Subject: FCC 15.247, RSS-247, and RSS-Gen Class 2 PERMISSIVE CHANGE for Murata Electronics North America, Model WIT 2450, FCC ID: HSW-2450 and IC: 4492A-2450

The purpose of this report is to file for a Class II permissive change for the following reasons:

Class 2 Permissive Change Letter
June 4, 2018
Page Two

Figure 1 is a block diagram of the original architecture. Figure 2 shows the architecture proposed for this Class 2 Permissive Change.

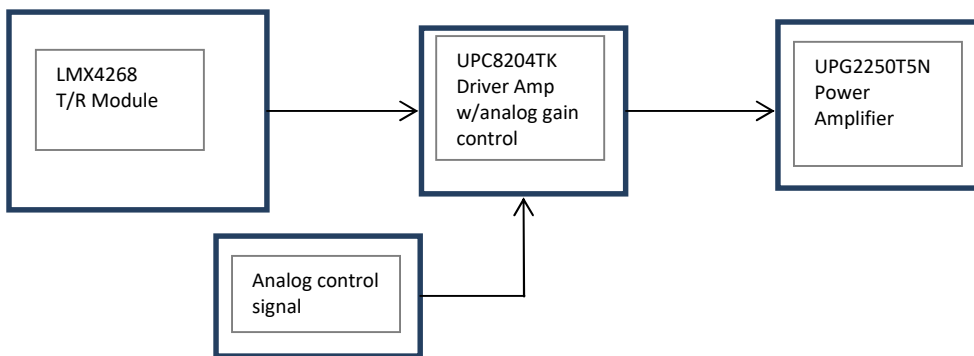
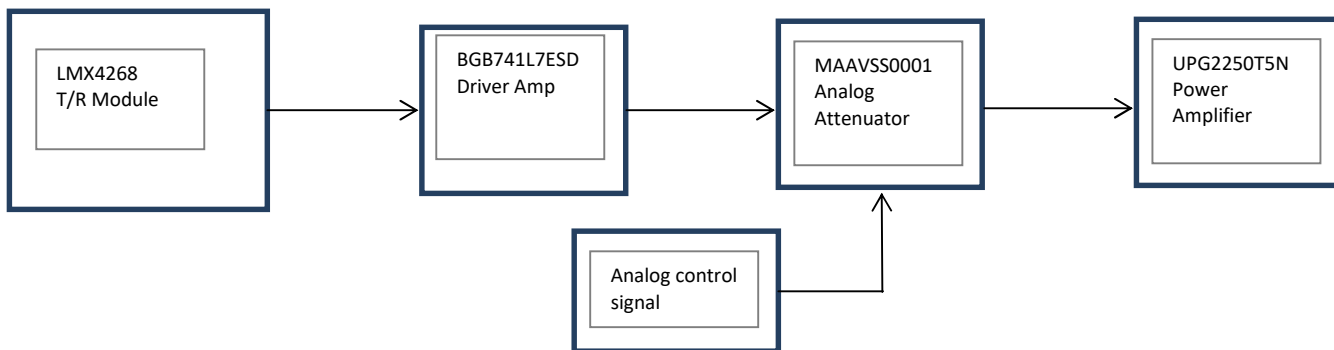
- Previous driver amplifier with gain control (DA_AGC) has been substituted to a separate amplifier and an analog attenuator to achieve gain control.
- Component changes and reorganization. A list of component changes follows:

Component was	Component is	reason for change
Gain control driver amplifier UPC8204TK	Driver amp BGB741L7ESD Analog Attenuator MAAVSS0001	UPC8204TK went obsolete, no other gain control amplifier is available at this frequency at this power level, so a driver amplifier combined with an analog attenuator yields the same functional performance
Bias/matching components for UPC8204: C34,C202,C217, L305,L309 R202,R31,Q3, C37=6.8pF R30,	Bias/matching components for BGB741L7ESD: C222,C223,C224,C225,L28,L29,R411,R413 Bias/matching for MAAVSS0001: C219,C220,C221, C37=0ohm	Components for UPC8204 removed with UPC8204 Components for BGB741 and MAAVSS0001 added with those components. C37 is now stuffed as a resistor.
R48=0ohm, R50=51=0ohm	R48=2.2nH, R50=51=.5pF	For matching to new driver amp
L304=22nH	L304=10nH	Better power from power amplifier
C212=C213=1pF	C212=C213=.5pF	Better filtering of high frequencies

C39=.5pF,C106=10pF	C39=1pF,C106=0ohm	Matching to MAAVSS0001
